Project	IEEE 802.16 Broadband Wireless Access Working Group < http://ieee802.org/16 >	
Title	CR on SDD Chapter 15: Facilitating Entry of New Femto BS into the Network	
Date Submitted	2009-07-2	
Source(s)	Karthik Sundaresan Sampath Rangarajan Linghang Fan	karthiks@nec-labs.com sampath@nec-labs.com linghang.fan@eu.nec.com
	NEC	
Re:	Category: SDD comments / Area: Chapter 15 (Femtocell) “Comments on SDD 15 Femtocell”	
Abstract	This contribution provides text addition to SDD to facilitate entry of a new femtocell BS into the network.	
Purpose	To be discussed and adopted by TGM for use in the IEEE 802.16m SDD	
Notice	<i>This document does not represent the agreed views of the IEEE 802.16 Working Group or any of its subgroups. It represents only the views of the participants listed in the “Source(s)” field above. It is offered as a basis for discussion. It is not binding on the contributor(s), who reserve(s) the right to add, amend or withdraw material contained herein.</i>

Facilitating Entry of New Femto BS into the Network

Figure 1. Femto/Macro Network Illustration.

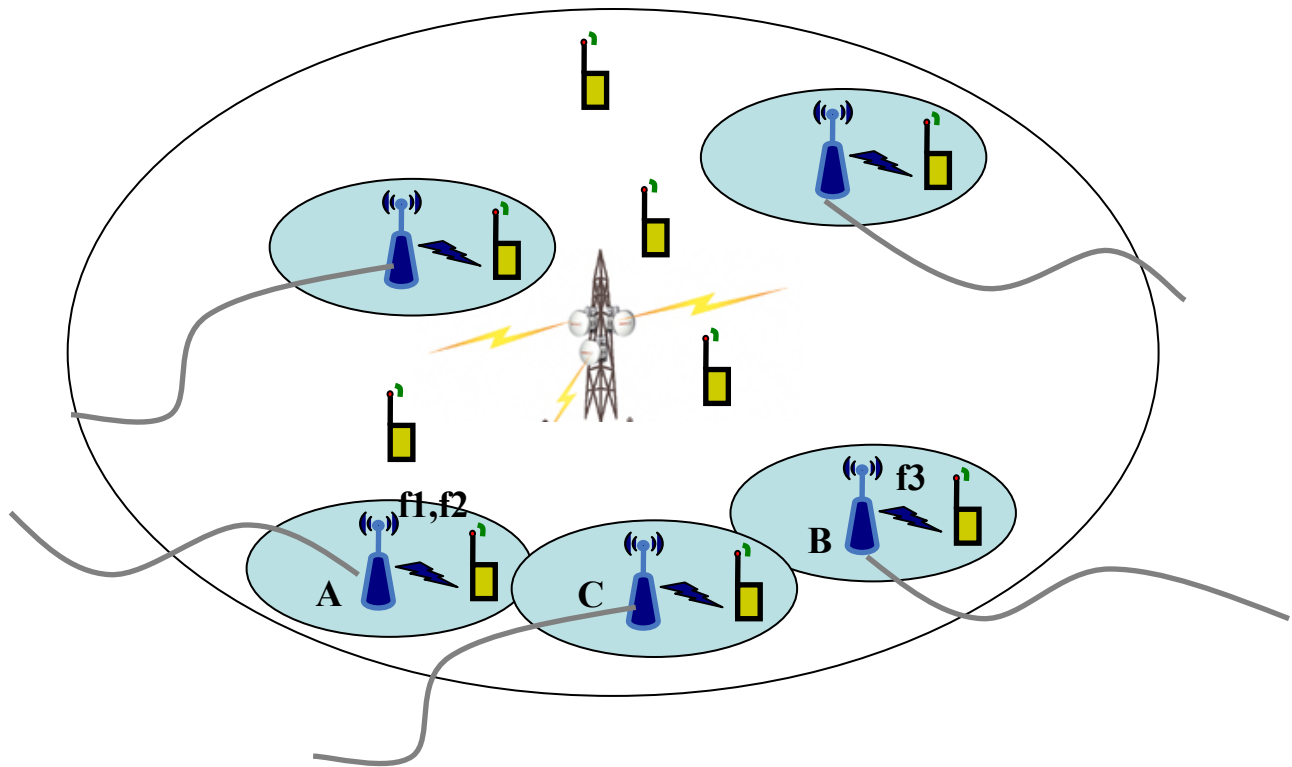
It is often possible that the macro BS may not be able to coordinate resource allocation among femto cells and the femto BS have to autonomously determine their resource region. This is especially likely in moderate to high load scenarios. The SDD currently specifies that a femto BS can measure power on all carriers from neighboring femto/micro/macro BS and accordingly choose a carrier perceived to have low interference for its MS. However, in moderate to high load scenarios, where the available resources are being fully utilized by existing femto BS, a new femto BS entering the network is likely to see high interference on all available resources from its neighboring femto/micro cells. Hence, a reactive approach of scanning for resources having low interference could potentially result in starvation of the new femto cell being deployed in the network. For eg., consider the scenario shown in Figure 1, where there are three carriers/channels available in the network: f_1, f_2 and f_3 . Femto BS A and B have already been deployed and split the resources as say $f_1 + f_2$ for A and f_3 for B. Now when

the femto BS C gets deployed, it finds strong interference on all the available carriers from its neighbors. This leads to starvation of the newly deployed femto BS C and its associated clients. This problem is exacerbated in cases, where there is no coordination of resources by a central entity like the macro BS or network controller and the femto BS have to autonomously determine their resource region of operation.

To address this starvation problem, it is essential for the femto BS to have the notion of “resource readjustment”. This essentially means that either (i) an entering femto BS must have the capability to “contend” for resources when it finds them to be occupied; or (ii) mechanisms for (centralized/distributed) resource allocation should be executed by the femto/macro BS either periodically or based on triggers (eg. entry of new femto BS). This would allow for resources to be shared fairly taking into account the change in network and load dynamics. In the above example, a periodic resource allocation mechanism or contention would trigger the three femto BS to enter into a resource re-allocation phase, whereby the three frequencies can get shared as f1 for A, f2 for C and f3 for B respectively.

It is possible that when a new femto BS is initially deployed, all channels (carriers) could be occupied by neighboring femto/micro BS. In such scenarios, the new femto BS will see high interference level on all channels, resulting in its consequent starvation. To avoid such scenarios, which are common in moderate-high load conditions, mechanisms (centralized/distributed) for resource allocation at the femto/micro BS can be enabled either periodically or based on network triggers.
